From: Howard, Leslie Ann CIV USN BRAC PMO SAN CA (USA) [leslie.howard@navy.mil]
Sent: Friday, October 23, 2020 12:50 PM
To: White, Jeff@Waterboards [Jeff.White@Waterboards.ca.gov]; Bacey, Juanita@DTSC [Juanita.Bacey@dtsc.ca.gov]; amy.brownell@sfdph.org; Low, Tina@Waterboards [Tina.Low@waterboards.ca.gov]; Ueno, Karen [Ueno.Karen@epa.gov]
CC: Robinson, Derek J CIV USN NAVFAC SW SAN CA (USA) [derek.j.robinson1@navy.mil]; Egan, Jamie [Jamie.Egan@jacobs.com]; Pauly, Brooks CIV USN BRAC PMO SAN CA (USA) [brooks.pauly@navy.mil]; Stoick, Paul T CIV USN NAVFAC SW SAN CA (USA) [paul.stoick@navy.mil]
Subject: HPNS Parcel E-2 Revised Draft Final Phase II RACR
Attachments: RTC - DF_RACR_Parcel E-2_Rf.docx; RTC - Attachments.pdf; FINAL_RACR_PE2_REDLINE.docx; FINAL_RACR_PE2_REDLINE.pdf; Table 5_FW_Conf Table (Rev1).pdf; Table 6_FW_Lead Excavation Conf Table.pdf; Table 7_TW Chemical Analysis Results_RC.pdf; 500506-B24-Fig 6 (Rev2).pdf; 500506-B25 Fig 7 (Rev2).pdf; 500506-B26 Fig 8 (Rev2).pdf; AppX_Table 1_Freshwater Wetlands Waste Characterization Analysis.pdf; AppX_Table 2_FW Waste Soil Metals_PreTreatment Characterization.pdf; AppX_Table 3_Parcel F Waste Soil Results.pdf; App Y_Water Quality Da

Remedial Action in Parcel E-2 - pH
07/1/2017 - 5/1/2018

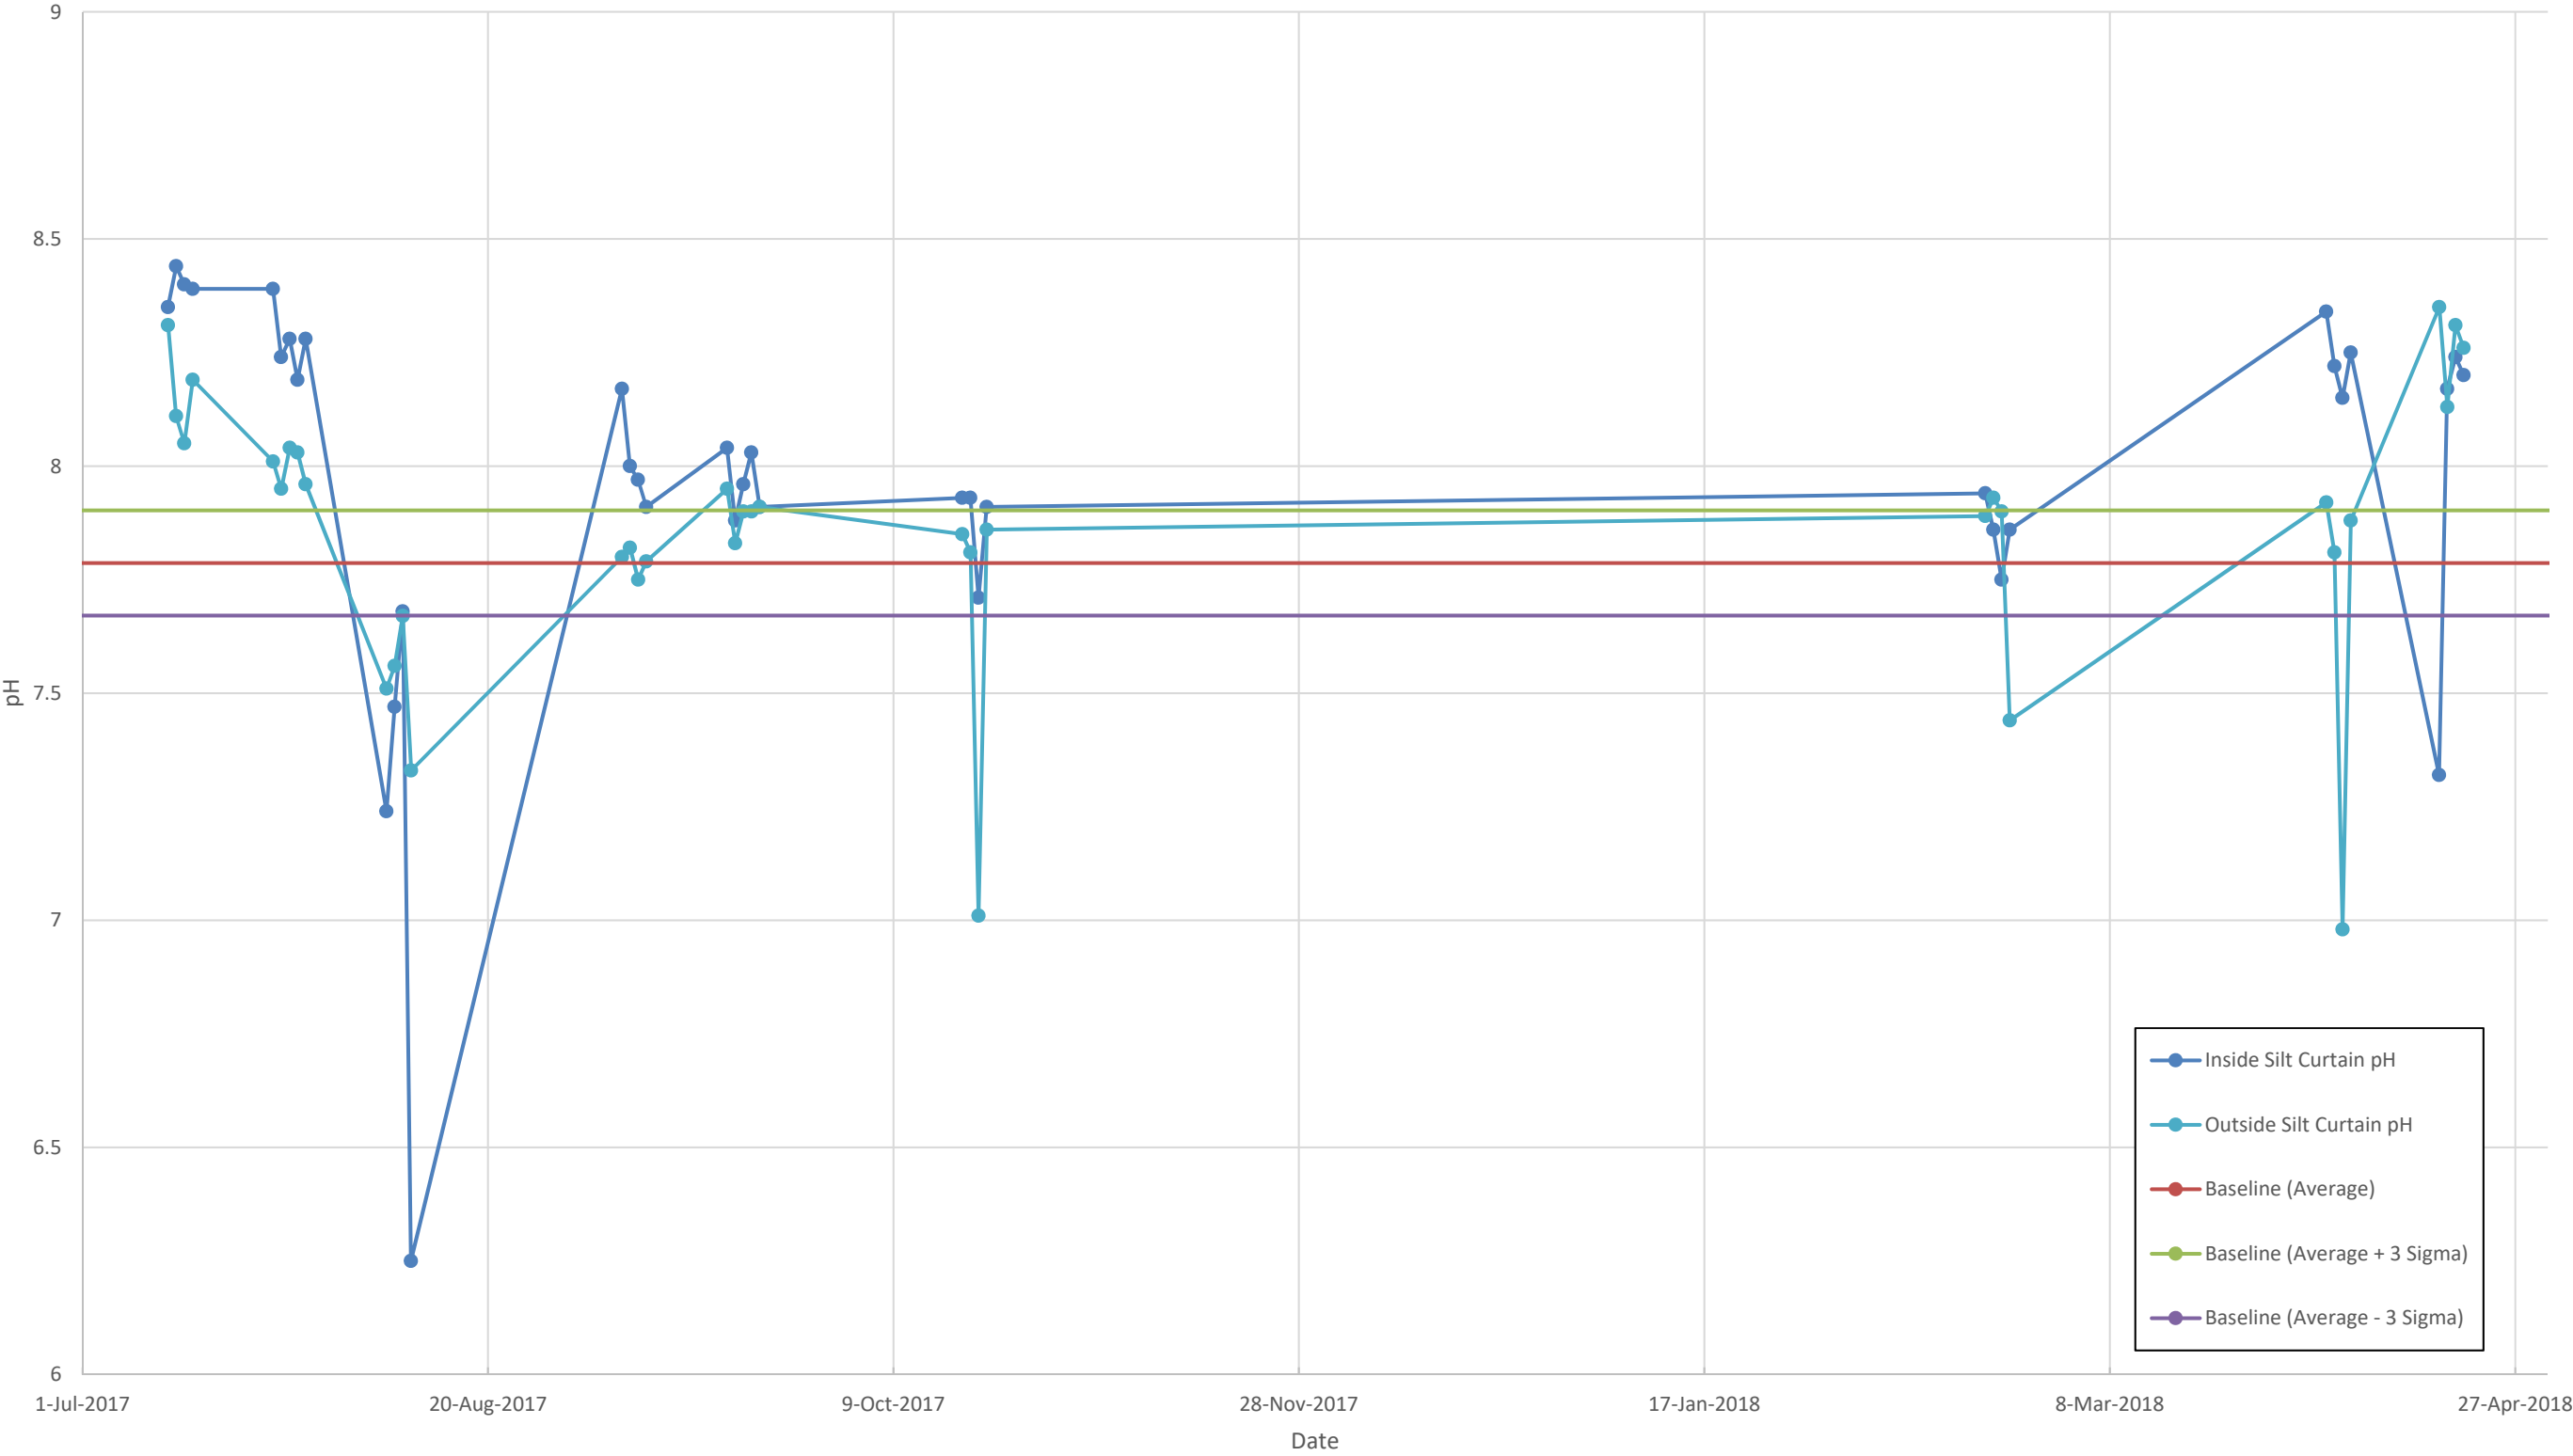
- Revised charts for Dissolved Oxygen, PH, and Turbidity (In response to DTSC comment 13)
- Appendix AA – Analytical Data and Validation Reports (in response to EPA comment 20)
